Village Work Session Meeting
Agenda
Tuesday, Oct. 6, 2026
Immediately following the Village Board Special Board Meeting

VILLAGE OF SOMERS
VILLAGE BOARD
WORK SESSION ITEM MEMORANDUM

SOMERS BUSINESS PARK
Burlington Road, Somers, WI

SHEET C-14 OF C-41

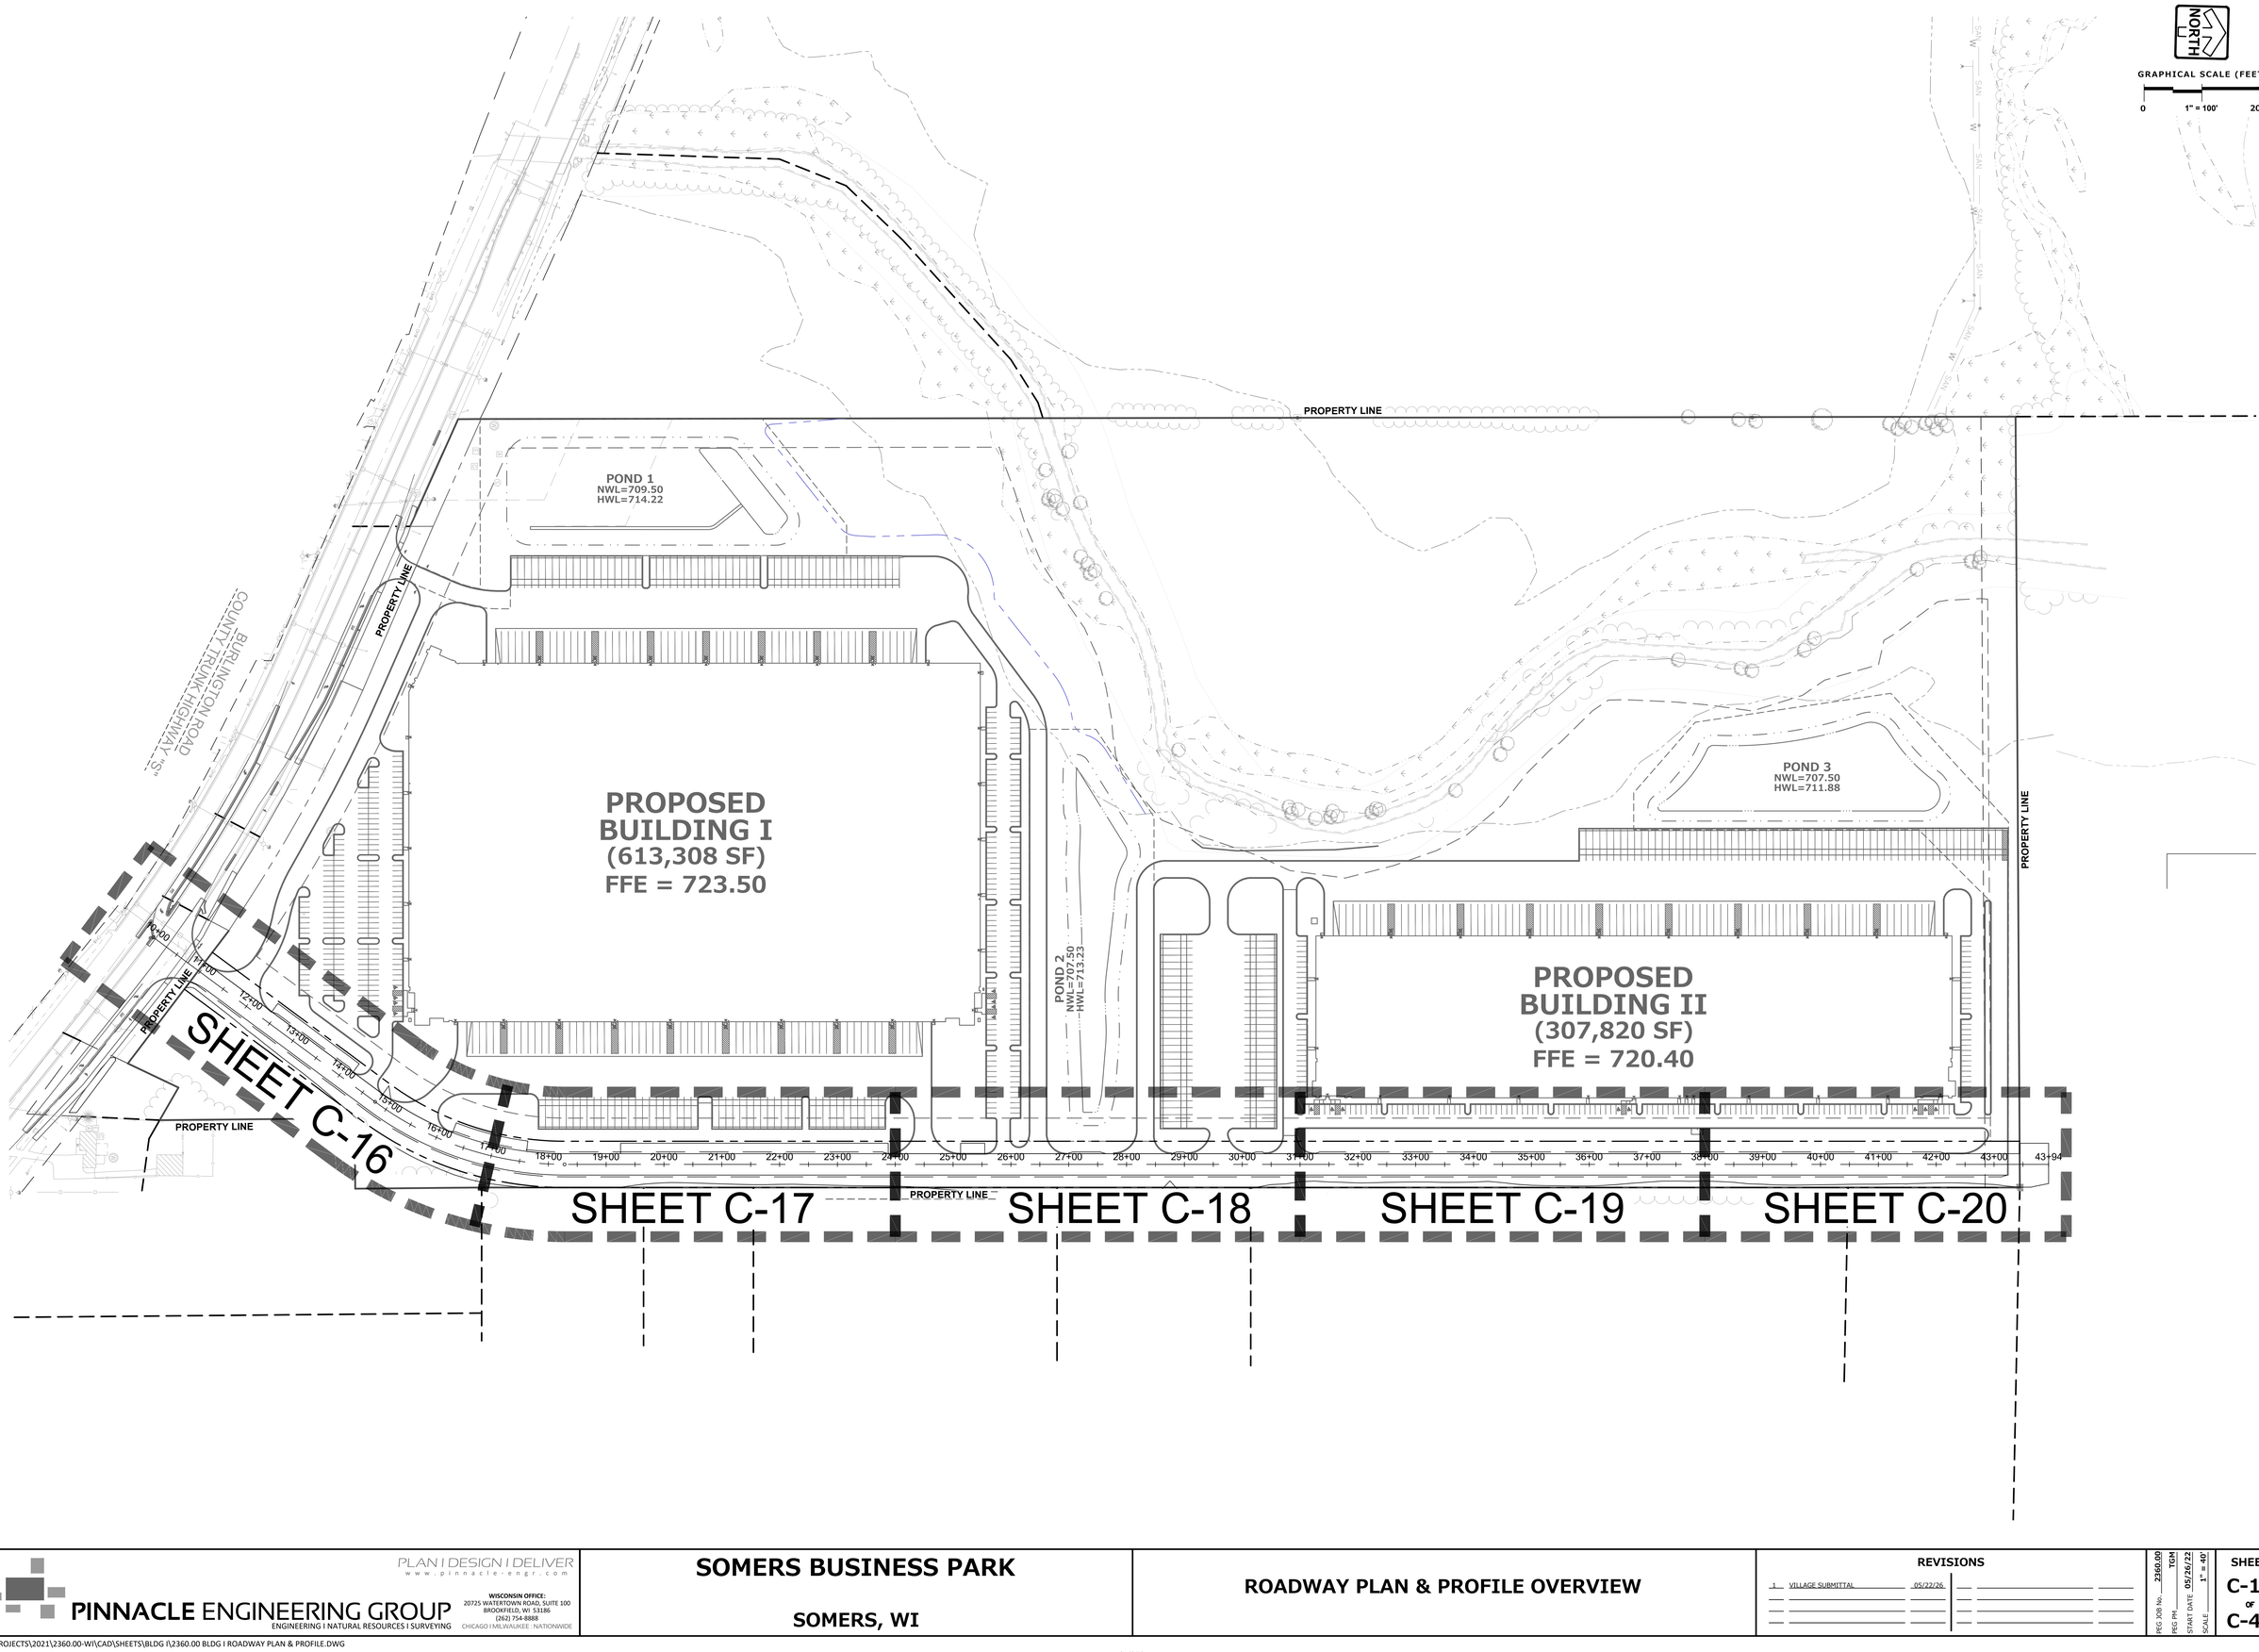
2. Sheet C-6: Provide a barricade and reflective signage at the north end of the public road.
3. Sheet C-14: Change dry hydrant intake pipe to RCP to match the detail.

4. Sheet C-14 and C-26: Show existing 12 inch force main along the north property line.
5. Sheet C-23: Adjust the watermain grades lowering the water main to avoid the storm sewer instead of installing an offset at sta. 18+50.

SHEET
C-36
OF
C-41

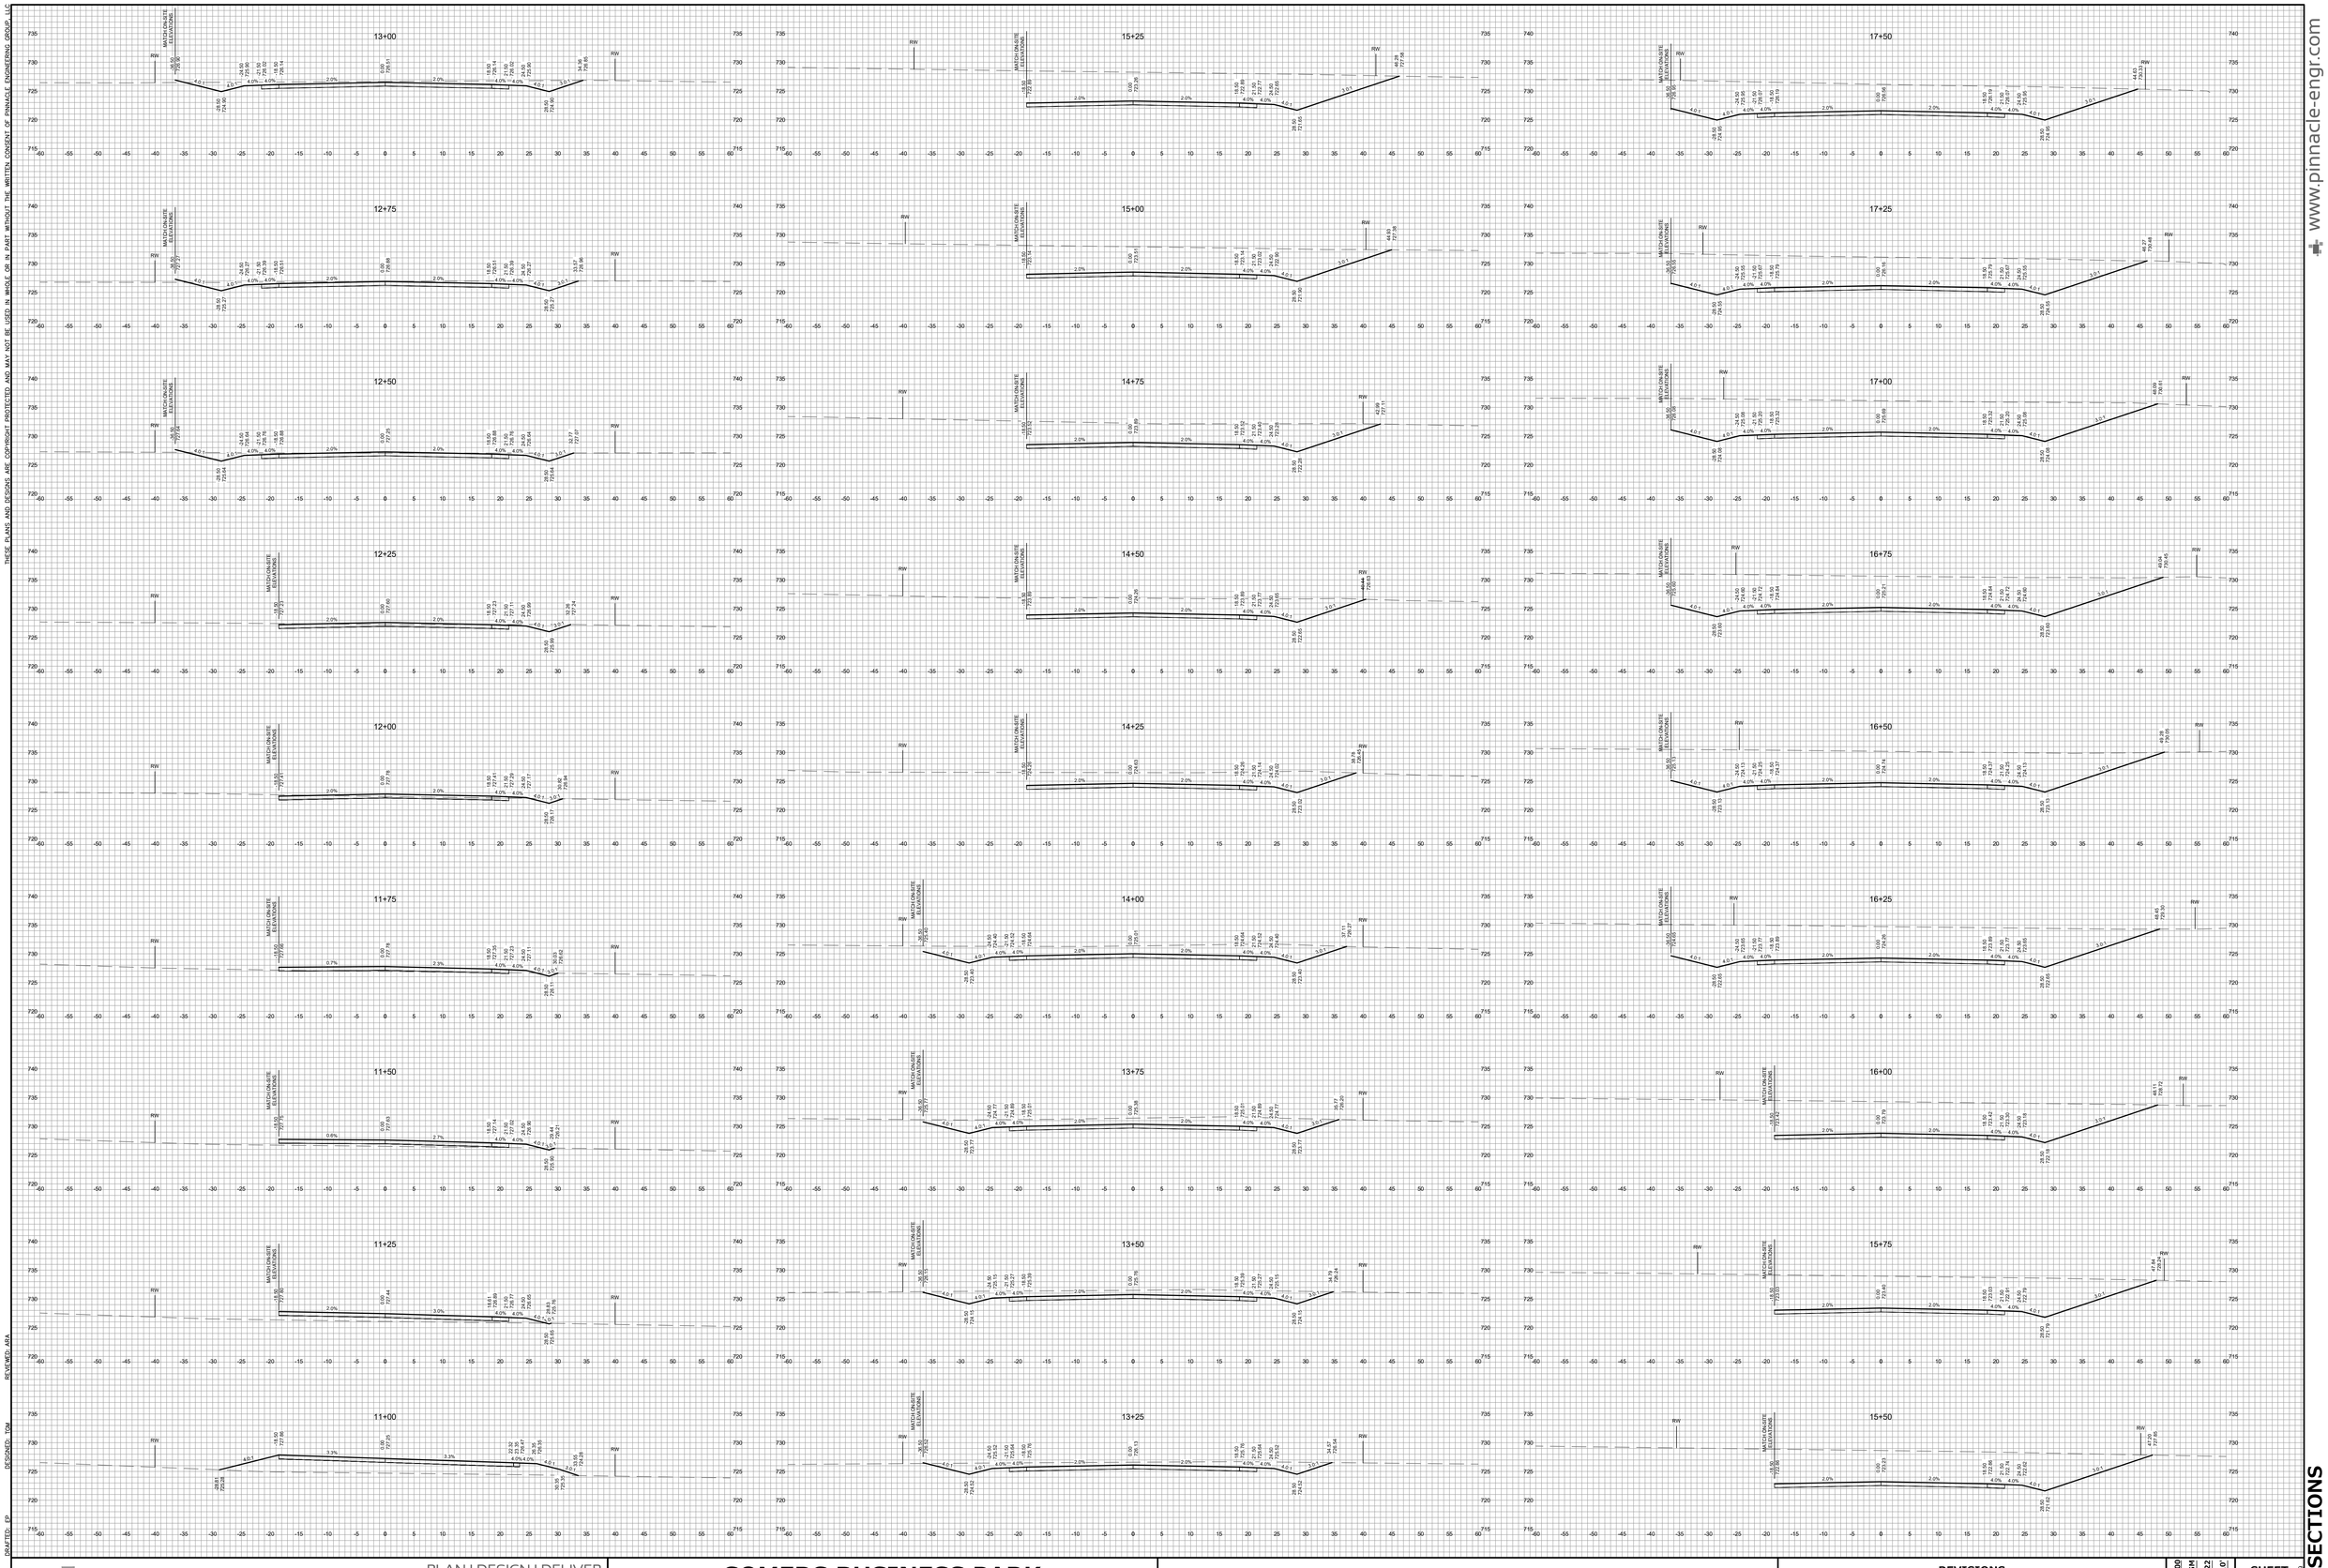
8. Sheet C-35: "Pond 2 Outlet Structure"
   a. Revise the orifice diameter to match the calculations.
9. Sheet C-36: Update the Village standards, attached.
